Product: TCD 3034

TANDBERG SERVICE INFORMATION

CONTROL AND ADJUSTMENT OF TAPE PATH ON T C D 3 0 3 4

Interference suppressor

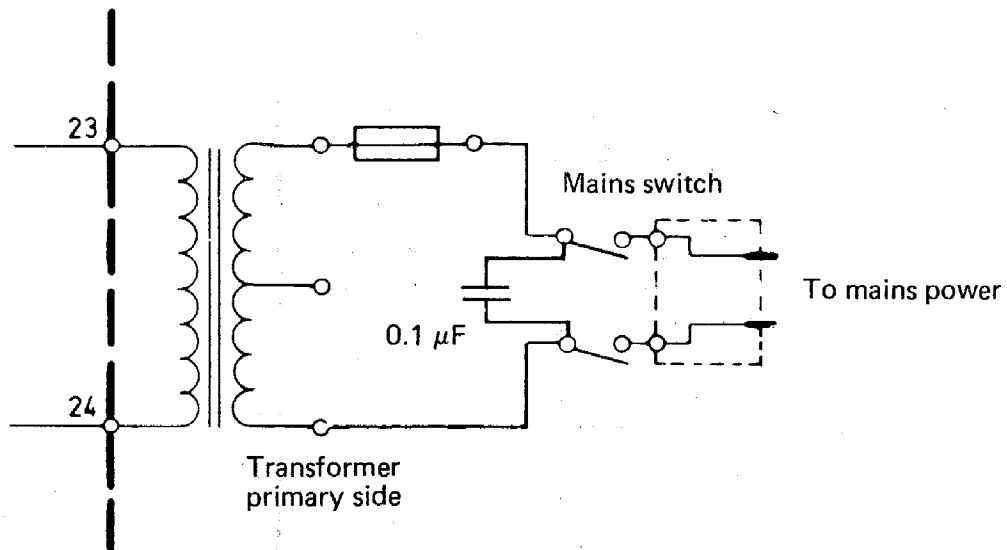
To reduce the noise when mains power is switched off, connect a $0.1 \mu\text{F}$ capacitor across the primary windings of the mains transformer.

In our production the capacitor is mounted on the mains switch.

For safety reasons the capacitor leads should be double insulated and soldered to the same terminals as the transformer primary wires.

Type of capacitor which is approved by NEMKO: RIFA PME 271M610.

PULSE MODIFICATION CIRCUIT

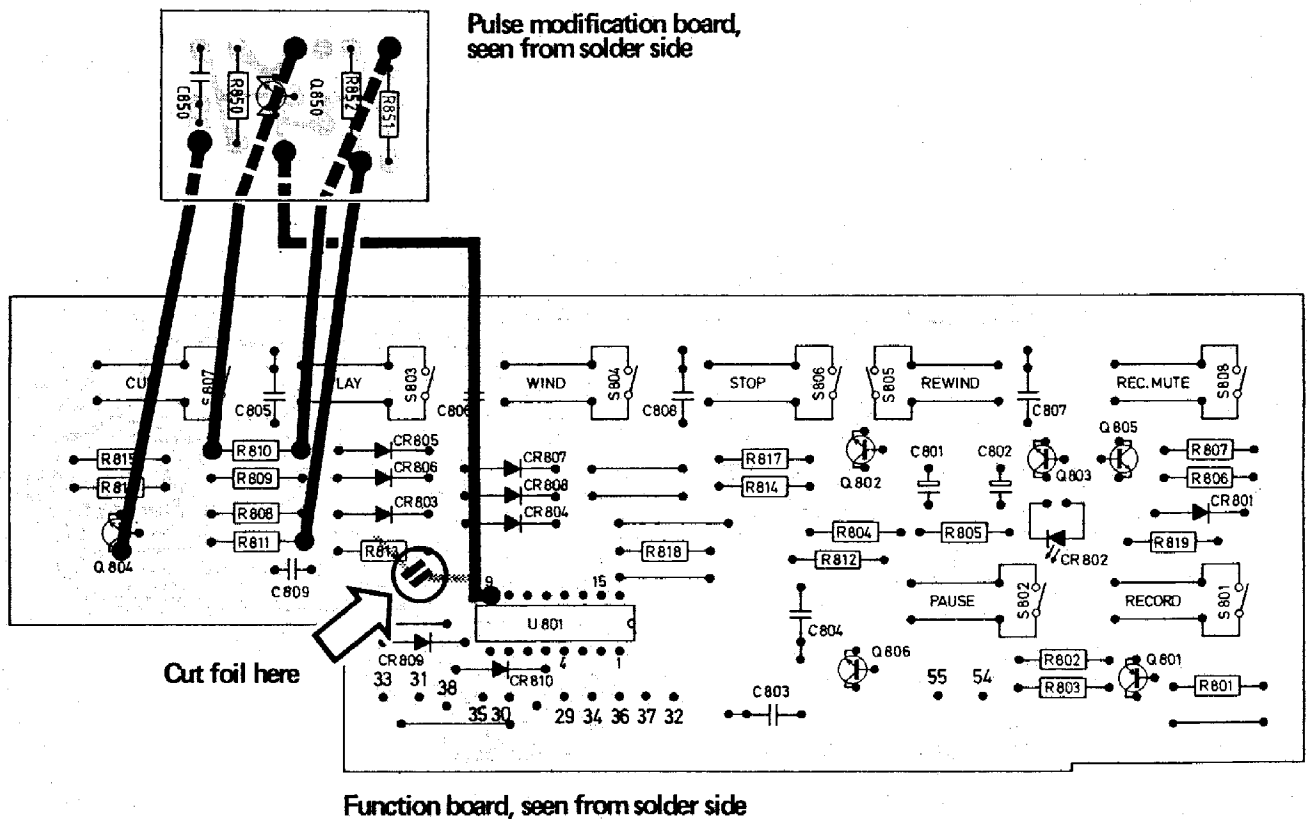
In some areas there are noise spikes on the mains voltage. The spikes can disturb the logic function so that the deck may fall out of play or fast winding modes.

To correct this, a pulse modification board can be installed on the function board. When this board is installed, the input 9 on U801 will have a high level, and make the deck less sensitive to noisespikes.

Cut the foil near the input 9 on U801 and solder on the board as shown in the figure below.

After installing the pulse modification board, you must check the end stop function. If the end stop has an intermittant function, then change:

R808 from 1 kohm to 4,7 kohm and
R809 from 12 kohm to 22 kohm.

- Position of cassette.

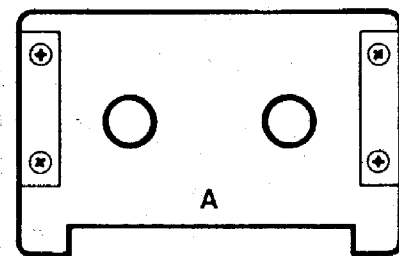
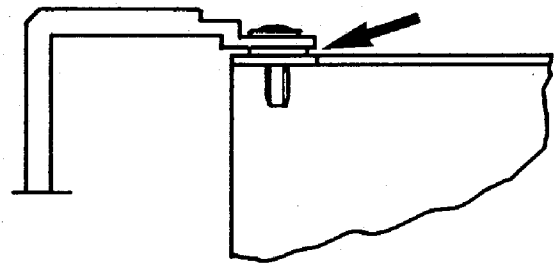
The cassette is not allowed to touch the front of the unit. If it does, 5 washers have to be placed under the 5 mounting screws. This to obtain a straight front cover. See fig.

Tape path gauge

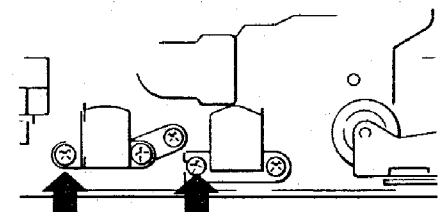
Part B of Tandberg tape path gauge is to move freely between the tape guides, see fig. The height can be adjusted with the adjusting screw shown on fig.

Part B of Tandberg tape path gauge is to move freely or slightly touch the tape guides. The touching must not be of such a character that part B loses its contact with part A. If the height is incorrect, something that seldom occurs, the washer under the mounting screw has to be replaced by a

- Pinch roller.

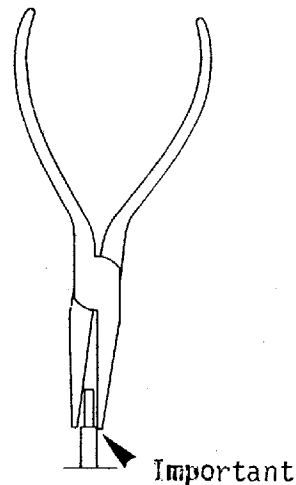
If the pinch roller needs adjustment the spring clip must first be removed, then carefully remove the spring from the bracket and at last the arm and bracket.

When applying a plier for adjustment it is very important to do it according to the figure shown.

- Pinch roller height.

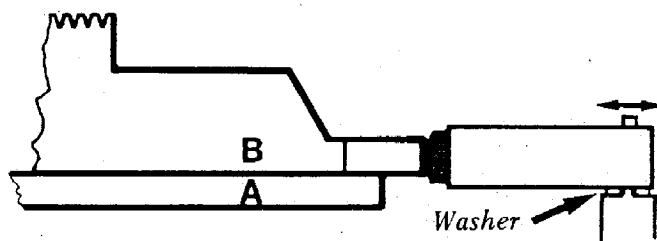
The shaft is to be bent as shown by the arrow - to the right if the pinch roller height is too low, to the left if it is too high.

To control it, the pinch roller is to be mounted (without spring and bracket) and part B of tape path gauge shall hit on the middle of the pinch roller.

The washer must not be removed when controlling.

- Parallelism.

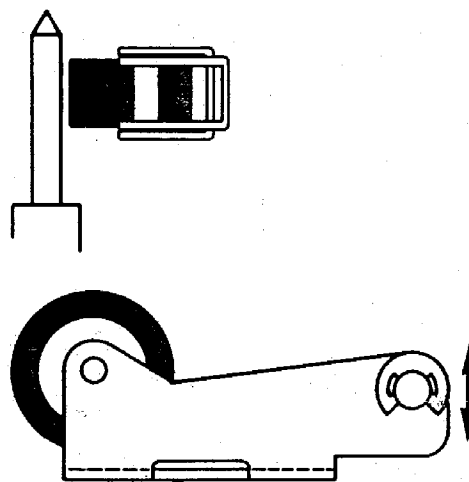
Mount enclosed tool (pinch roller arm with cylindrical pinch roller). Push the arm carefully against capstan. If the pinch roller is not parallel with the capstan, the shaft must be bent according to figure to obtain parallelism.

- Pinch roller pressure.

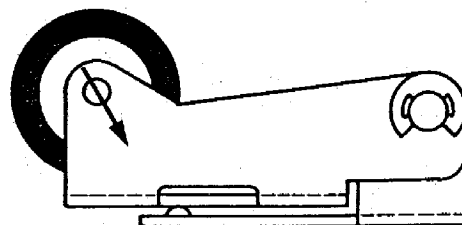
Using a 1 kg dial gauge the pressure is to be measured on the pinch roller arm in the direction shown by the arrow. The value is to be read when the pinch roller leaves the capstan. If the pressure is not between 475 and 550 gr. it shall be adjusted within the tolerance by

NEW PLATE ON TRANSFORMER.

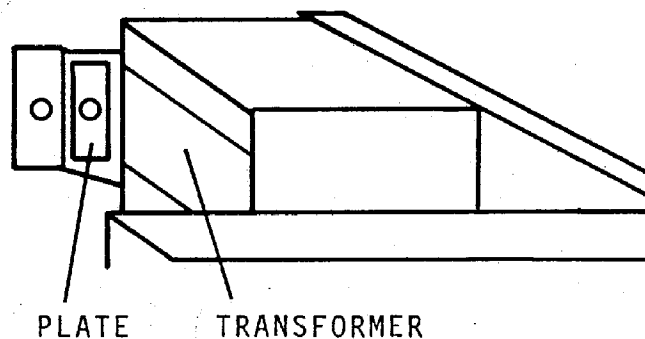
For better protection during transport, the power transformer is fastened to the bracket with a new plate. The new plate is approx. 2 mm (0,08") thick and has part No. 997463.

- Remove the top/side- and back/bottom covers, see Service Manual.
- When installing the plate, make sure a lock washer is placed between the plate and the nut.
- Take the green and brown power wires together and fasten the wires with tape to the upper part of the back cover.

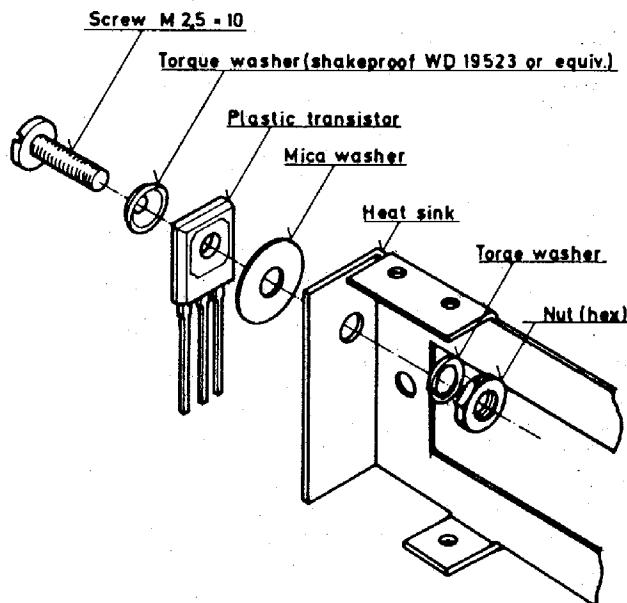
Internal tooth washers must be replaced by a torque washer (lock washer).

The internal tooth washer might damage the plastic house on the power transistors Q918 and Q703 after some time of operation.

The power transistors must be assembled as shown in the figure.

A torque of 6,9 kp/cm (6 in-lbs) is sufficient to keep the device firmly mounted. A maximum of 9,2 kp/cm (8 in-lbs) is specified, and if exceeded, the plastic may chip. Mounting torque in excess of 6,9 kp/cm (6 in-lbs) does not appreciably lower the case to sink thermal resistance. Use of the specified torque washer will keep the torque within safe limits by observing when the washer flattens slightly.

GROUNDING THE CAPSTAN MOTOR.

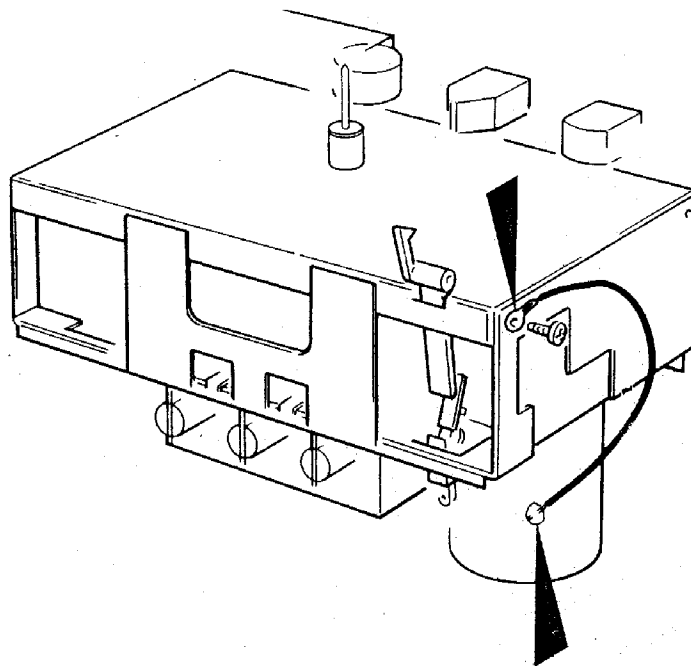
Sometimes the deck may fall out of play.
This can be corrected by grounding the capstan motor to
the bracket for the drive mechanism.

- Remove the top/side cover, see Service Manual.
- Remove some of the coating on the capstan motor to make a good soldering. Then solder a wire of approx. 7,5 cm (3") to the motor. Solder the other end of the wire to a soldering tag and fasten the soldering tag on to the bracket for the drive mechanism with the screw as shown in the figure.
